Planning Application for Proposed Hotel (Student Hostel) (Partial Conversion of Existing Commercial Building) with Minor Relaxation of Plot Ratio Restriction in “Residential (Group A)” Zone, at Kowloon Inland Lots Nos. 9432 and 9433, 10 Anchor Street, Tai Kok Tsui, Kowloon (Application No. A/K3/604)

– *Further Information (3)*

Responses-to-Comments (“R-to-C”) Table dated 2.9.2026

– Further Information (4)

Figure 15a – Existing Parking Spaces and Loading/Unloading Bay in the Vicinity of the Subject Site

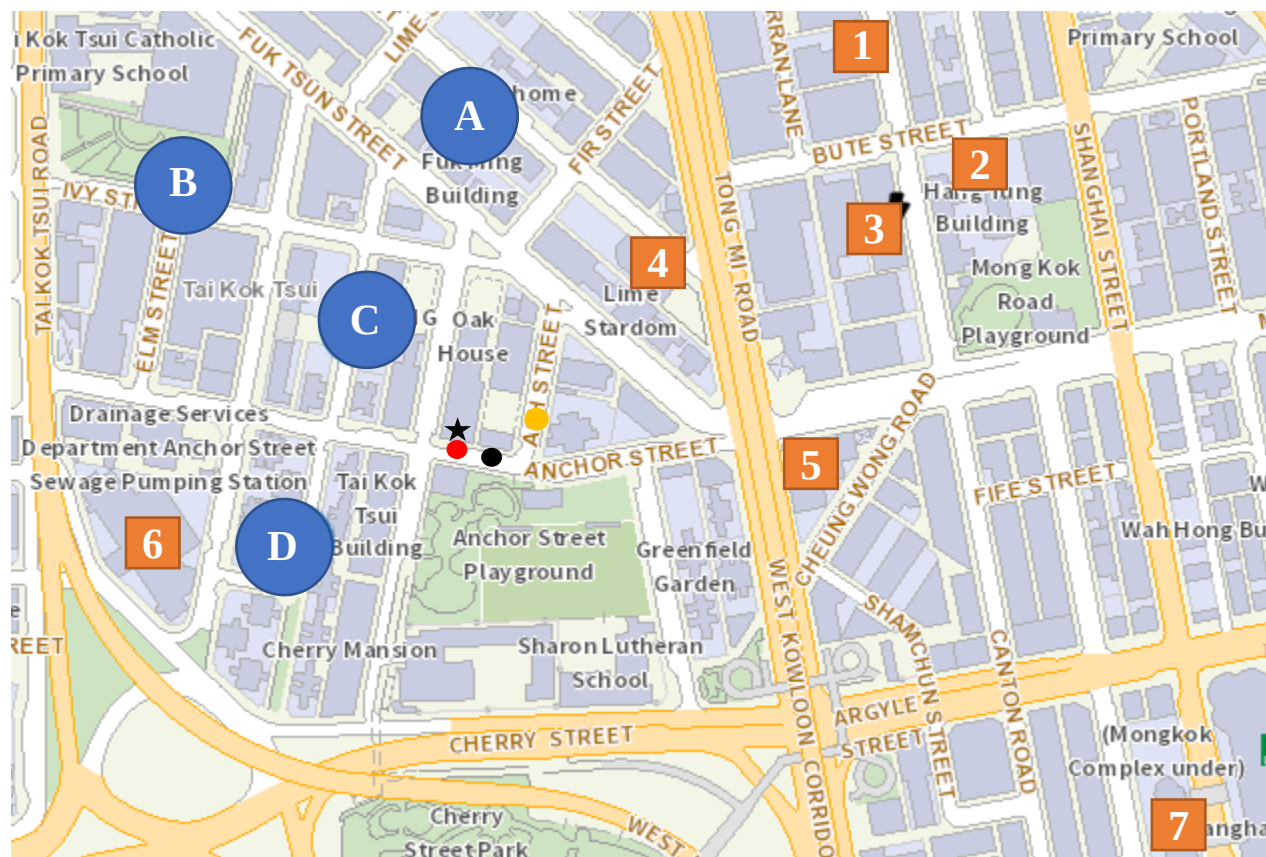
1.	<i>The applicant is required to review the provisions of parking spaces and loading/unloading requirements of the proposed student hostel against the requirements in HKPSG. Therefore, the applicant shall provide the required provision of parking spaces and loading/unloading spaces in accordance with HKPSG and compare the requirements</i>	Referring to the Parking, and Loading/Unloading Requirements Standards for Hotels (Main Urban Areas & New Towns) under HKPSG, it is required to provide 1 car parking space per 100 rooms, 0.5-1 loading/unloading bay for goods vehicle per 100 rooms.

Departmental Comments	Applicant's Responses
<i>against the available number of parking spaces and loading/unloading spaces in the vicinity.</i>	The proposed student hostel would provide 83 hostel rooms. Hence, 1 car parking space and 1 loading/unloading bay for goods vehicle is considered sufficient in accordance with the HKPSG requirements. 1,000 car parking spaces are provided at the Hang Tung Building in the vicinity of the Subject Site (Annex C). There are also several on street metered parking space and private car parks located in the vicinity (Figure 15a in Annex C). Please also refer to Figure 15a (Annex C) for the location of the loading/unloading bay for goods vehicle.

Figure 6b – FLOOR PLAN OF G/F

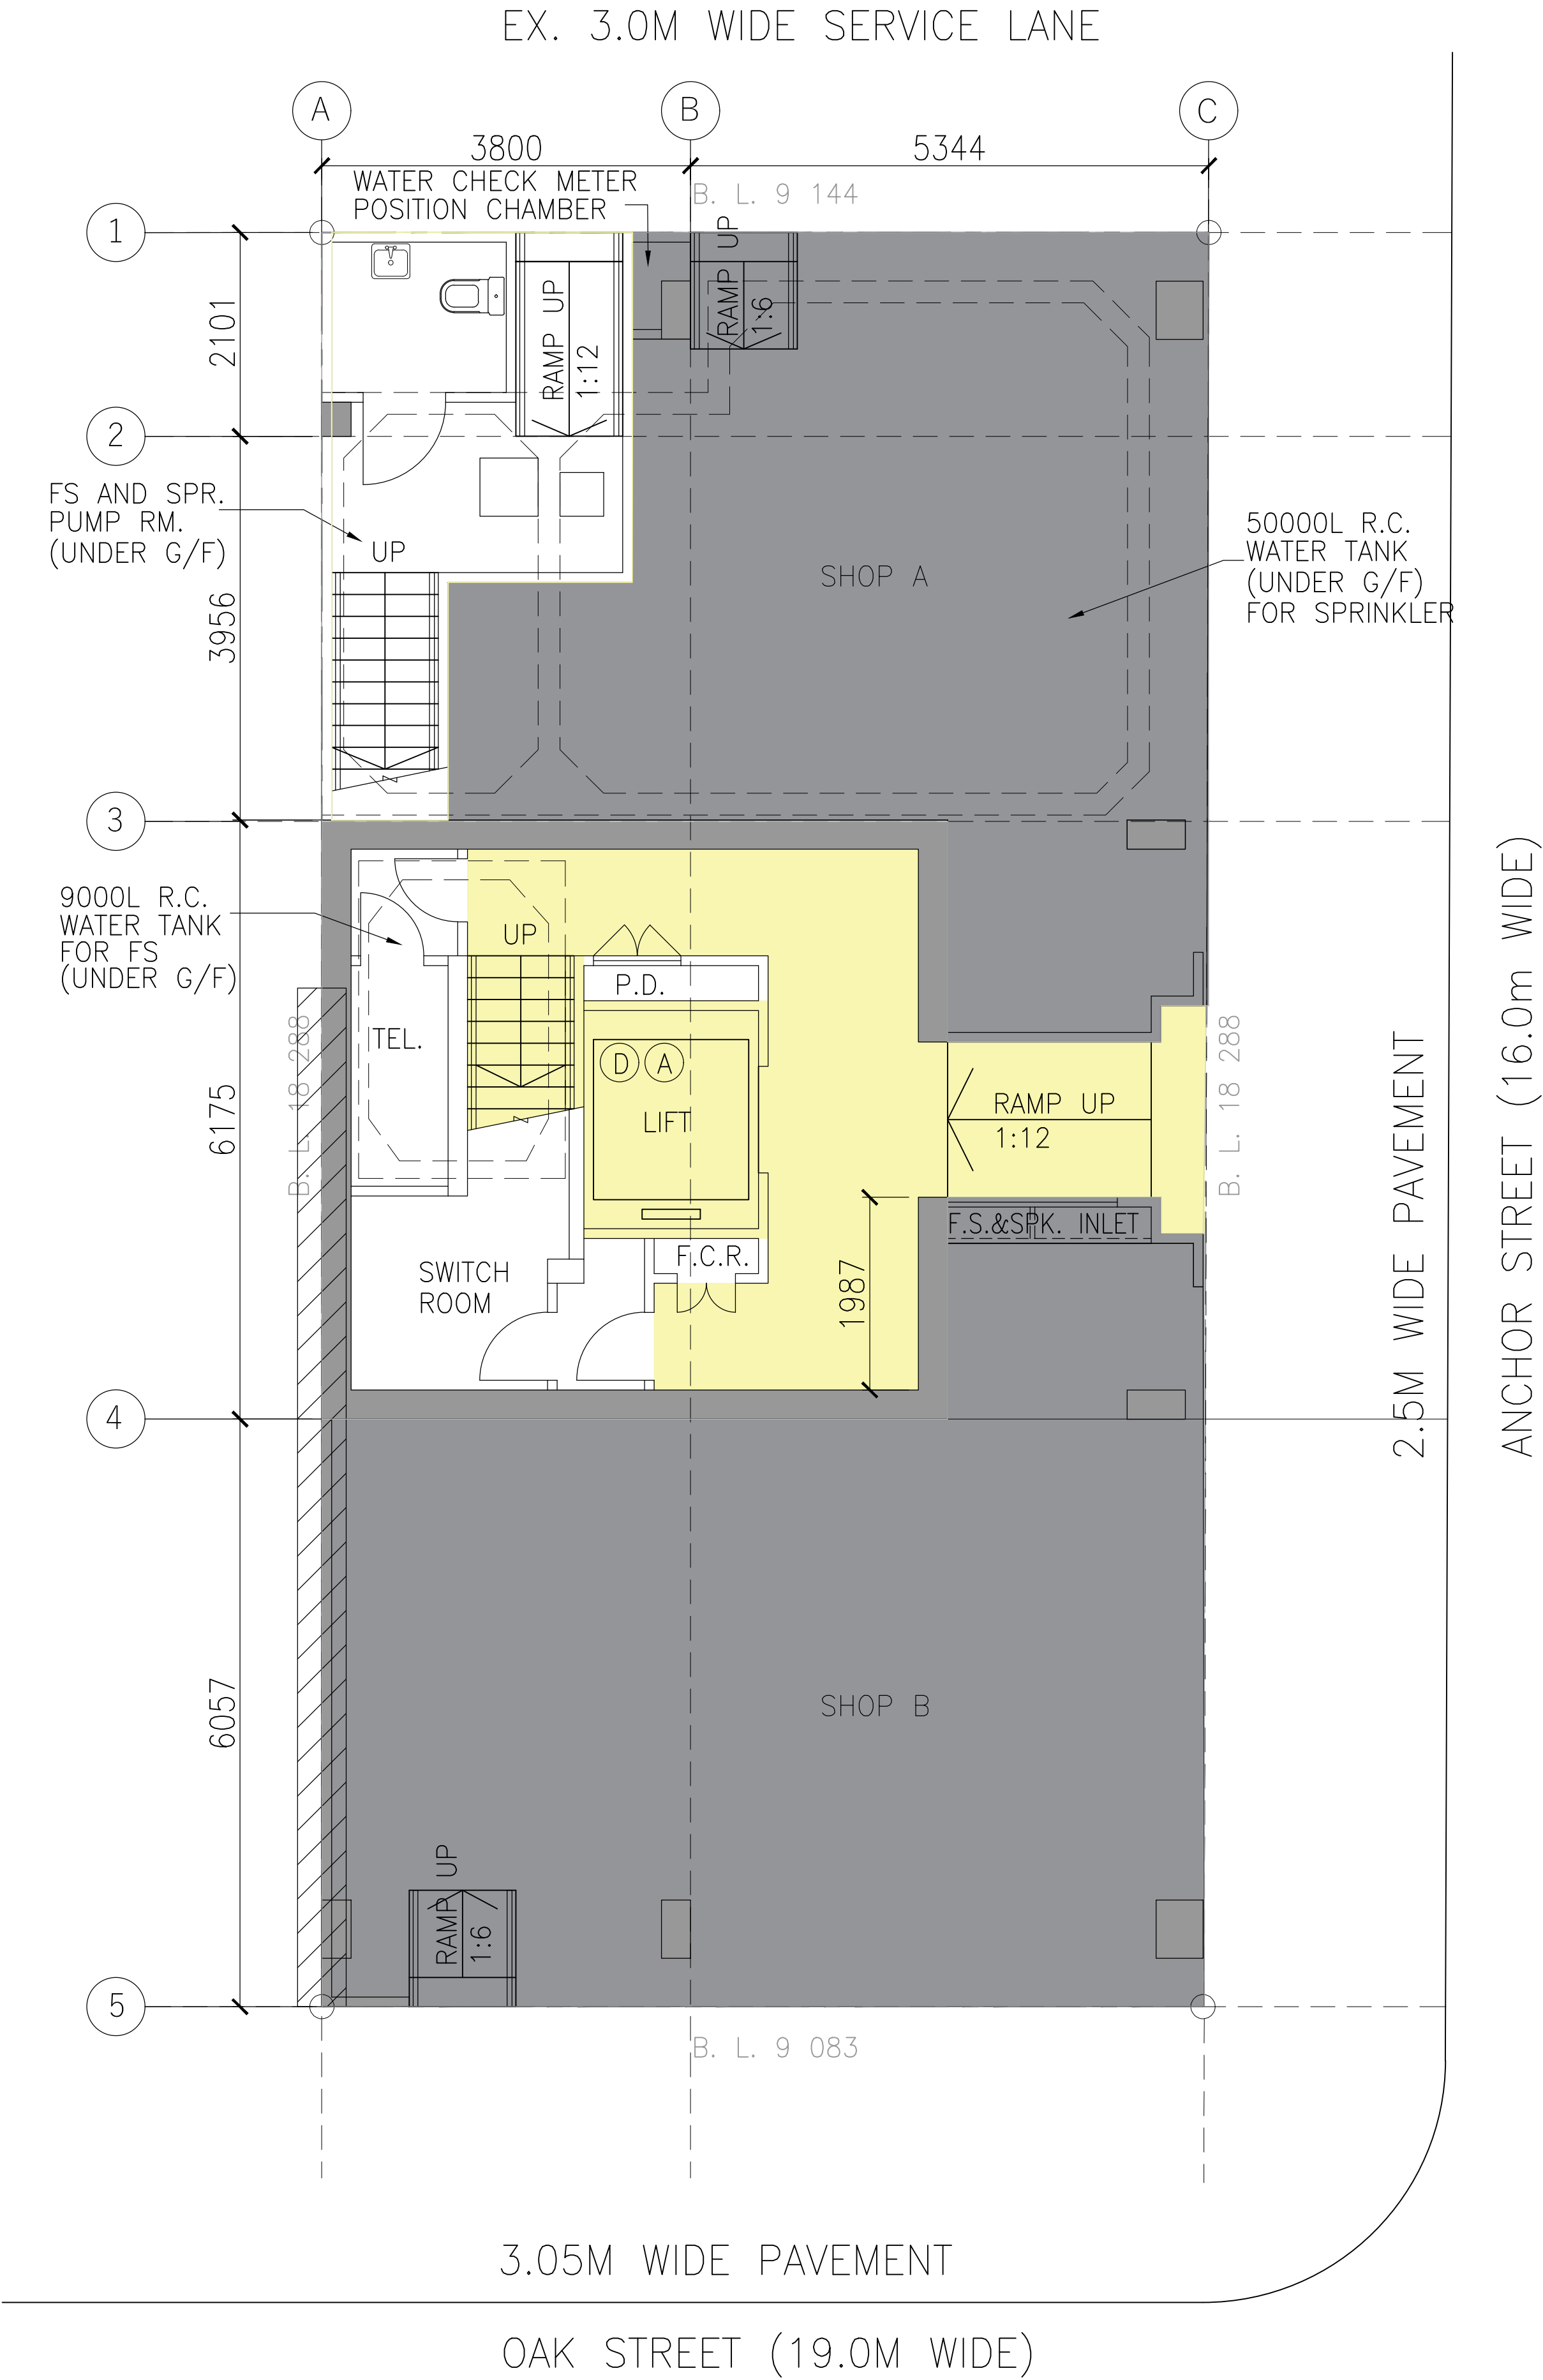
Departmental Comments	Applicant's Responses
A. Secretary for Education and the Head of Development Projects Facilitation Office, Development Bureau (received on 3.9.2026)	
1. It is noted that some of the areas shaded in yellow on the G/F in the updated Figure 6a does not form part of the eligible Scheme. The aforementioned yellow area is extracted below for easy reference: 	An updated Figure 6b is provided at Annex A accordingly. The new figure has now been updated and this revised figure should be incorporated into future amendment to EDB.

Departmental Comments		Applicant's Responses
B.	Tsuen Wan and West Kowloon District Planning Office, Planning Department (received on 3.9.2026)	
1.	Discrepancy: ☒ The student hostel will only take up parts of the new building/partial conversion <i>[Please specify the following]:</i> (1) the GFA of proposed student hostel portion and its percentage out of the total GFA of the proposed/existing building; 1838.239 sqm (95%) Please note that the GFA breakdowns of the Building are: Student Hostel Portion (G/F Lobby and 1 to 14/F): 1,829.839m² Commercial Portion (Existing Shops A & B at G/F) 104.507m²	The discrepancy noted earlier was due to a difference in calculation methods. Specifically, the area in the EDB submission was calculated by taking the total GFA from the GBP record minus the area of the two shops on the G/F. Student Hostel (G/F lobby and 1/F - 14/F) – 1,810.194m² Existing shop and restaurant at G/F (not forming part of application) – 104.507m² Please also note that the area not forming part of the application at G/F (indicated in white in the G/F Plan) includes G/F escape staircase and toilet, which account for a GFA of 19.645m².

Figure 15 – Existing Parking Spaces and Loading/Unloading Bay in the Vicinity of the Subject Site

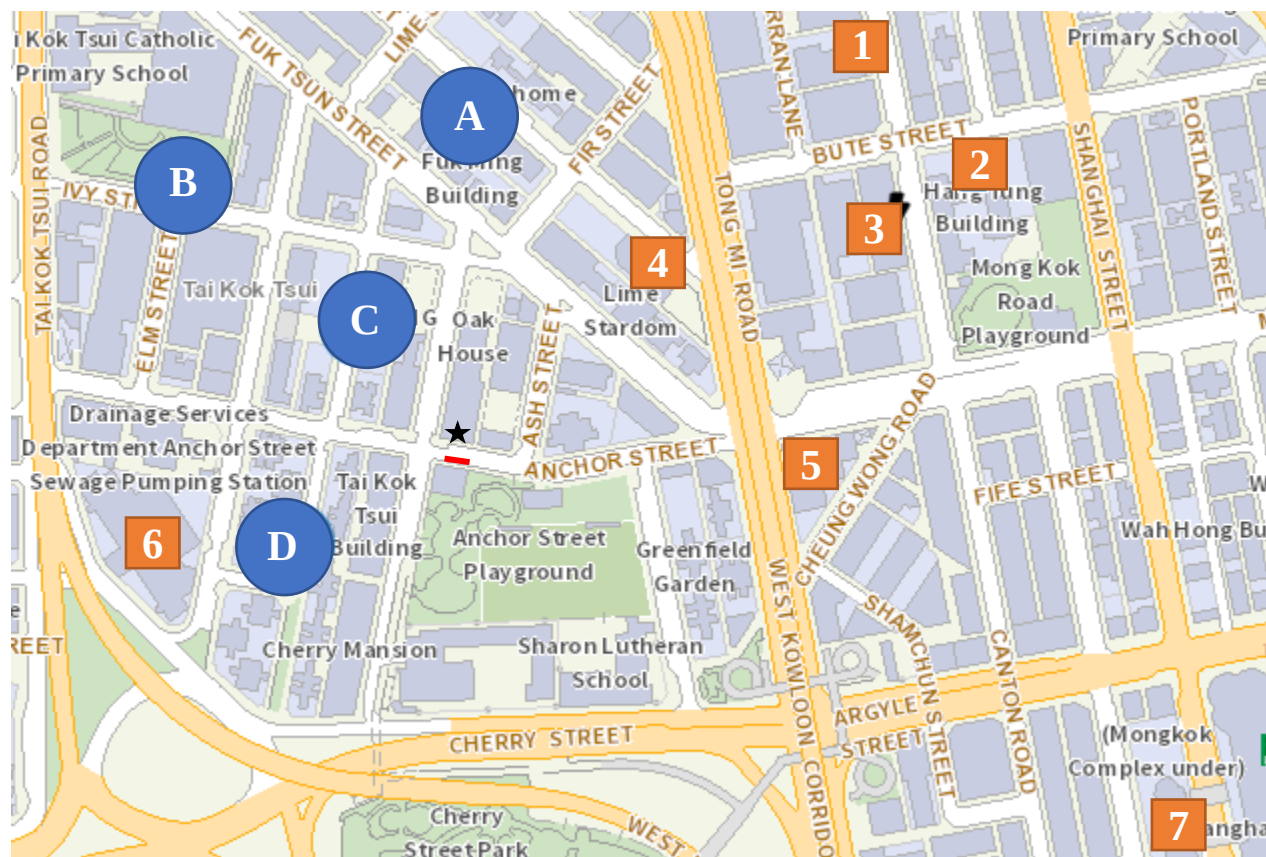
Departmental Comments		Applicant's Responses
A.	Transport Department (received on 28.8.2026)	
i.	<u>Please review the provisions of parking spaces and loading/unloading requirements of the proposed student hostel against the requirements in HKPSG.</u>	This Application involves only internal conversion of an existing building, an eligible hostel recognised by EDB. However, as requested, Figure 15 in Annex A shows the parking space and loading/unloading provisions in the vicinity of the Subject Site.
ii.	The applicant should be reminded that C for T has the rights to impose, alter or cancel any car parking, loading/unloading facilities and/or any no-stopping restrictions, on all local roads to cope with changing traffic conditions and needs. The frontage road space shall not be reserved for any exclusive uses of the subject development.	Noted.
